Service kit Drive Cable Set (part # 61S4FR6107889)

Service Manual

Doc. no.: 33H4206A

Hollandia 400

Drive cable routing

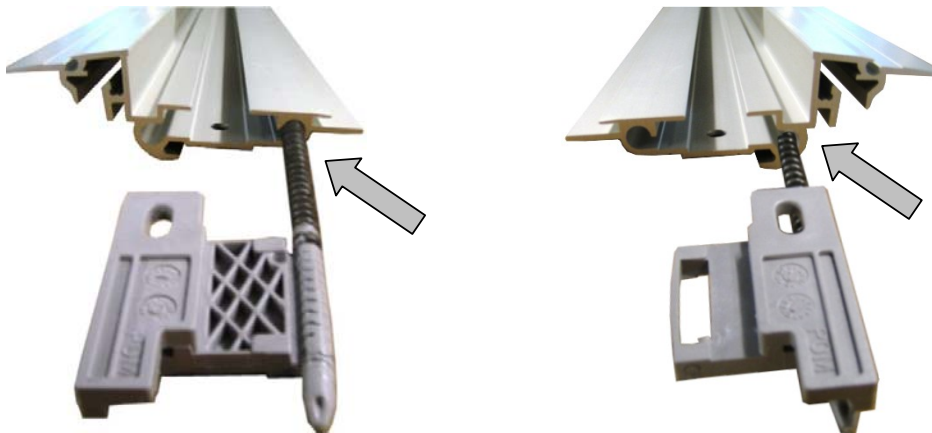
- Hollandia 400 Classic with serial number until 17710: modified routing compared with original;
- Hollandia 400 DeLuxe: same routing as original.

LEFT side of vehicle:
Routing through right (inner) channel.

RIGHT side of vehicle:
Routing through right (outer) channel.

Verlegung Antriebskabel

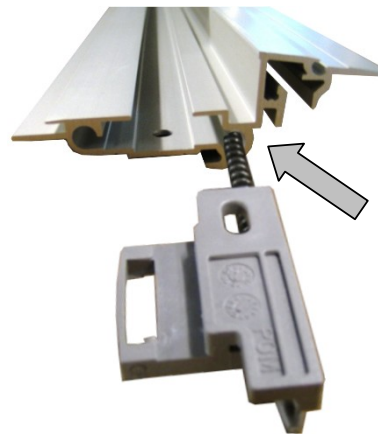
- Hollandia 400 Classic mit Seriennummer bis 17710: geänderte Verlegung im Vergleich zum Originalzustand;
- Hollandia 400 DeLuxe: wie im Originalzustand.

LINKE Fahrzeugseite:
Kabelführung im rechten (inneren) Kanal.

RECHTE Fahrzeugseite:
Kabelführung im rechten (äußeren) Kanal.
